# UNITED STATES PATENT AND TRADEMARK OFFICE

10/582,543

<b>Office Action Summary</b>	<b>Application No.</b> 10/582,543	<b>Applicant(s)</b> ANDERSSON ET AL.	
	<b>Examiner</b> Allen J. Flanigan	<b>Art Unit</b> 3744

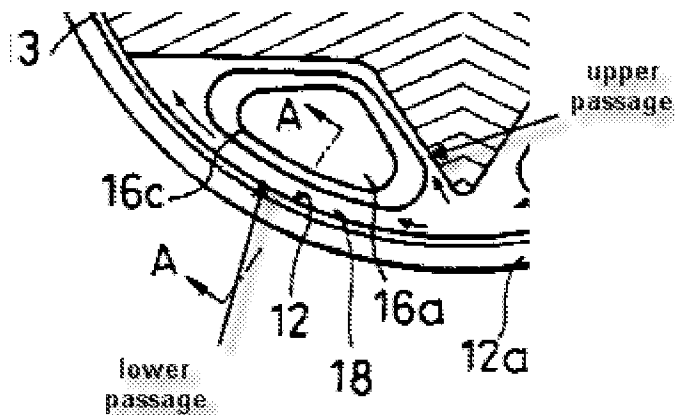
Yoshioka et al. show a stacked plate heat exchanger with plates brazed together to form interleaved passages for two fluids exchanging heat. The problem of stagnant flow near sealed off pass through ports for the other fluid is dealt with in much the same way as the claimed invention, i.e. by the provision of dual passages that encourage flow around the sealed port (see Figs. 3 and 4):

Although Yoshioka et al. employs the term “brazing” instead of “soldering” to refer to the means of joining the plates to each other, the terms are considered equivalent in that both refer to a fusion bonding process involving fusible alloys that have melting points lower than the material being joined. Regarding the claimed “ridges”, either the raised portions 10a, 12 shown in Fig. 4 and/or the terminal region of the herringbone ridged pattern of the plates would be readable on the claimed ridges, as these elements at least partially define the passages that surround the port 16a.
